**BUREAU OF PARKS AND LANDS
GRIFFITH HEAD BRIDGE RECONSTRUCTION, BGS #3207**

REID STATE PARK, GEORGETOWN, MAINE

Addendum #1

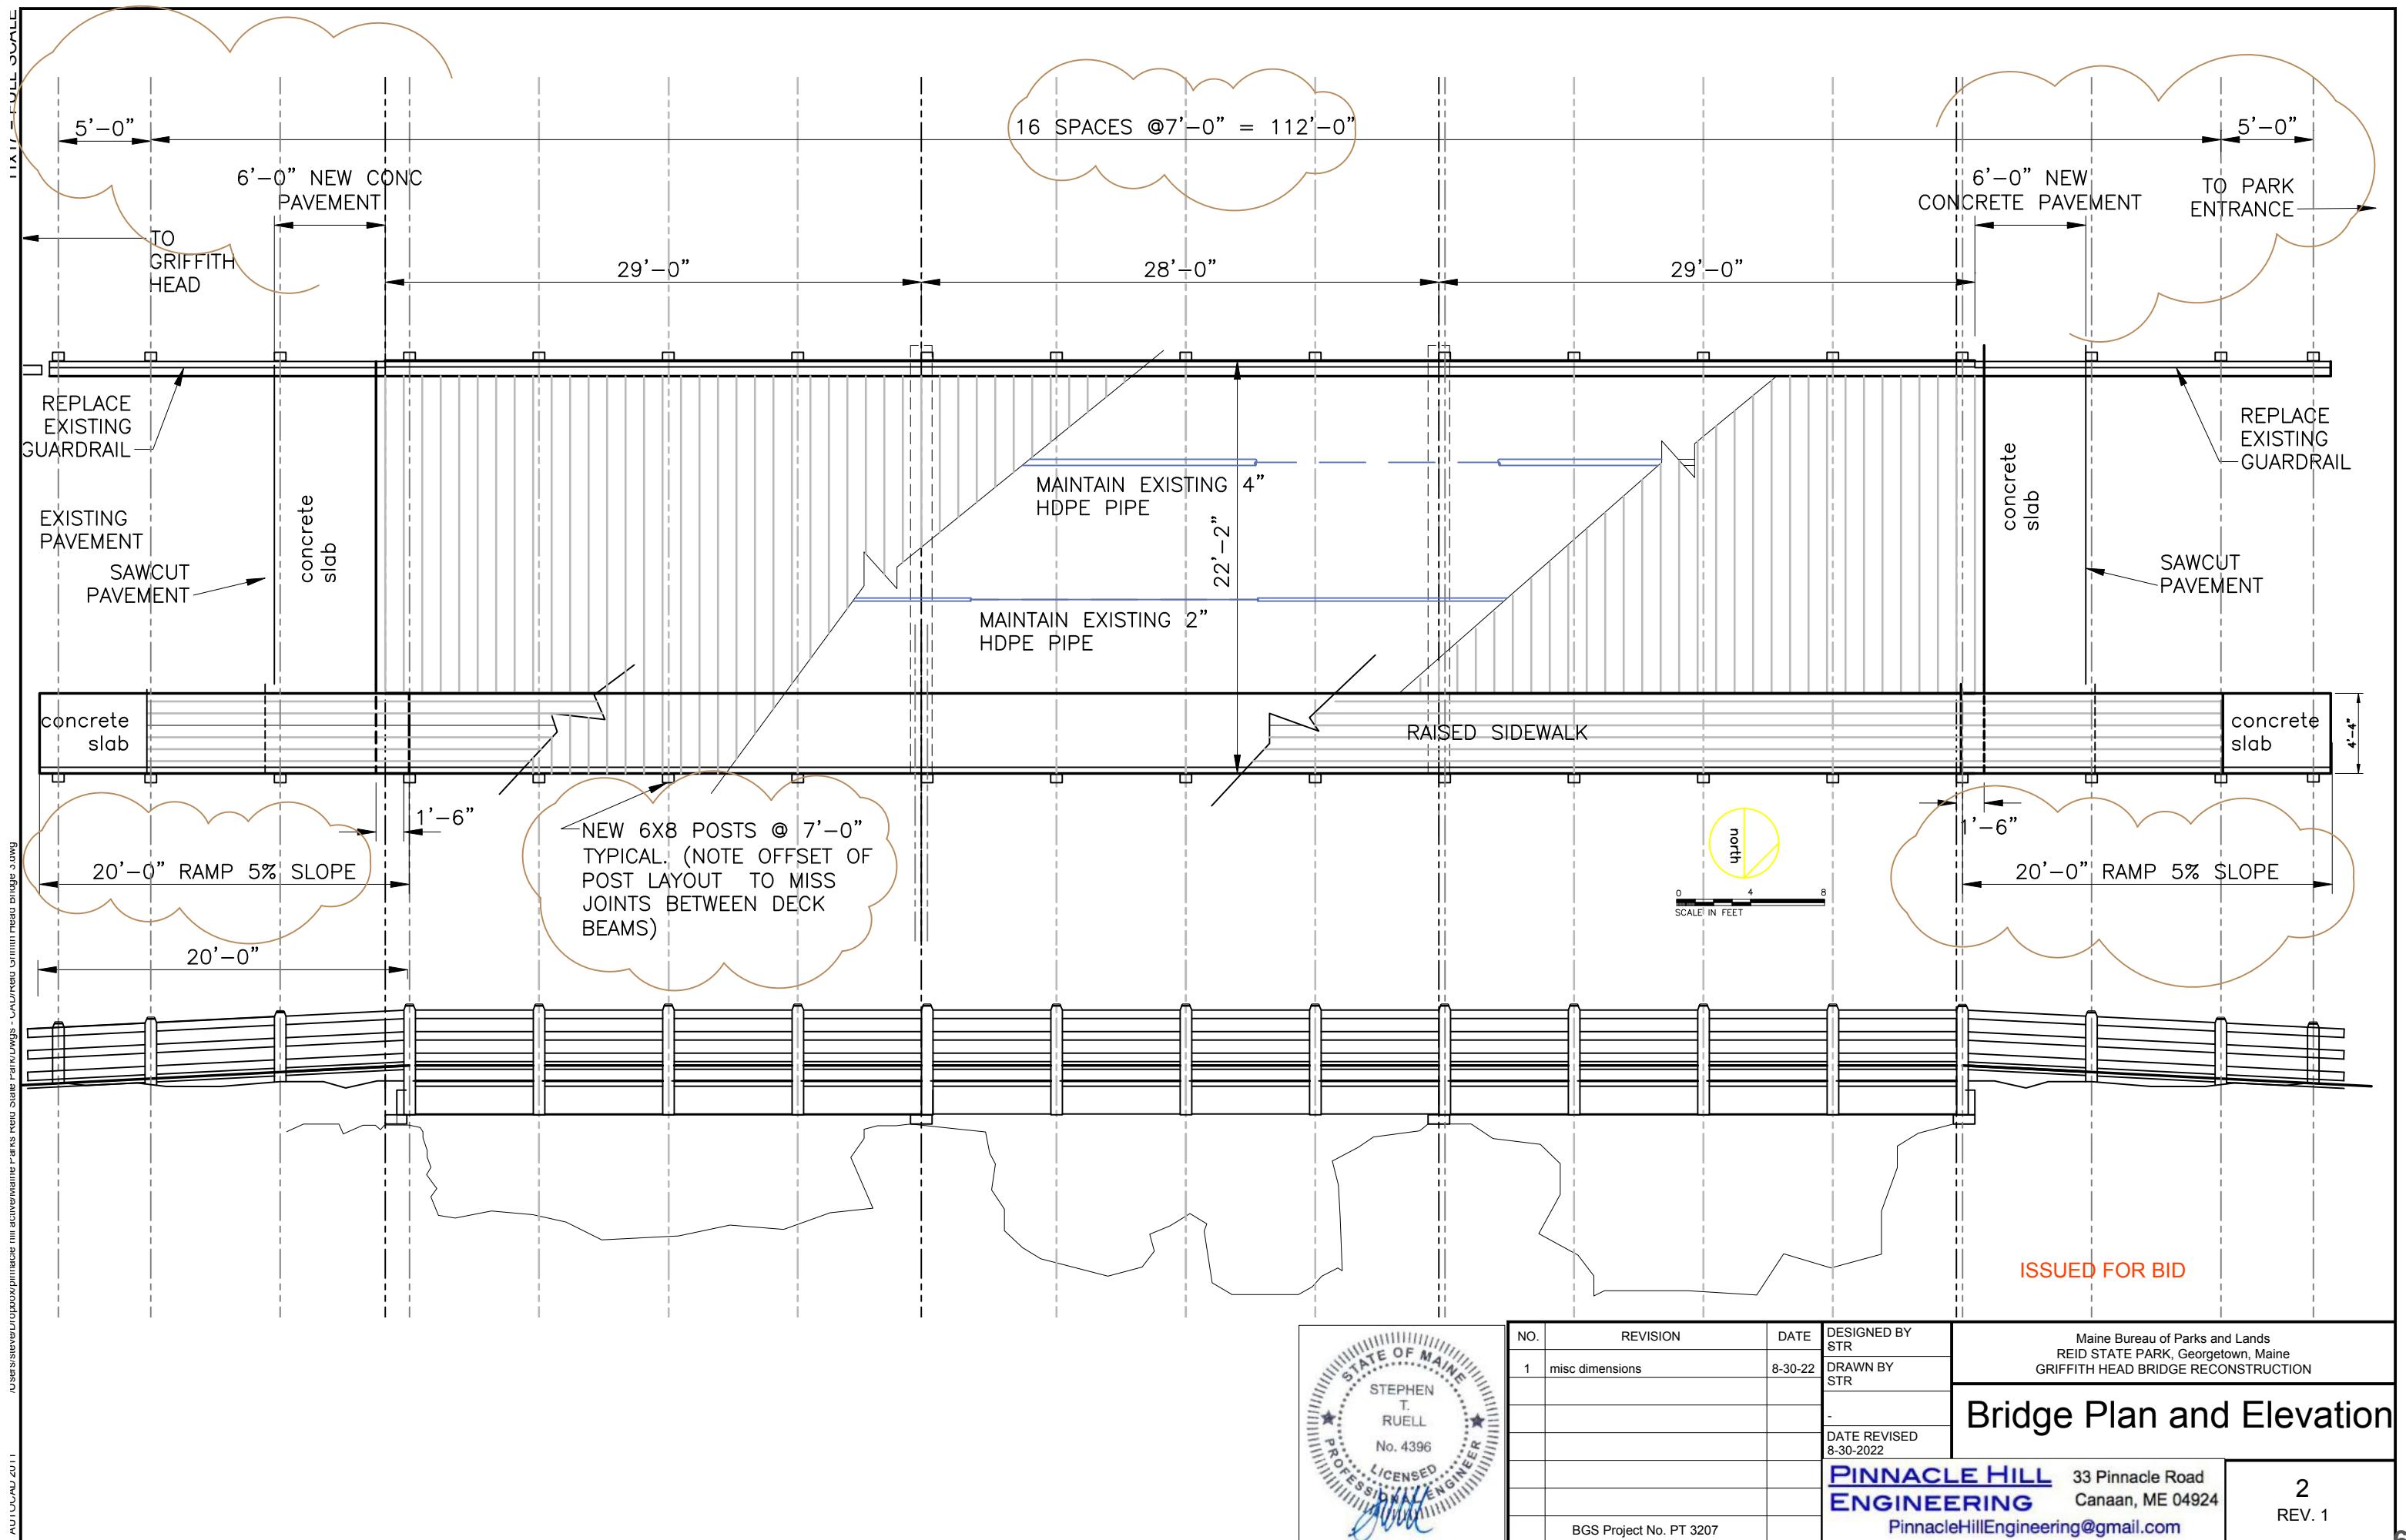
1. Plan Sheet #2
 - A. Rev #1 is attached as a correction for several items. The dimensions of the concrete slabs on sheet 2 Rev 0 were missing. The concrete extends 6'-0" from the edge of the timber deck. The concrete extends the full width of the roadway and will terminate against the stone masonry on each side. The roadway width is irregular due to the shape of the stones.

- B. The guardrail posts are all 6x8 nominal. The note referring to 6x6 is updated.
2. Plan Sheet 4
 - C. The glue laminated diaphragms are shown in this plan but difficult to see in some places. The diaphragm blocks are between the deck beams in five staggered rows of 13 blocks (at each of the two interior piers and at midspan of each span). Also a diaphragm block is needed at each of 8 additional post locations along each exterior railing. 13 pcs x 5 locations = 65 pcs and 1 at each of the 16 post locations= 81 total diaphragm blocks. The exact length of the blocks is subject to the final dimensioning of the deck beams.
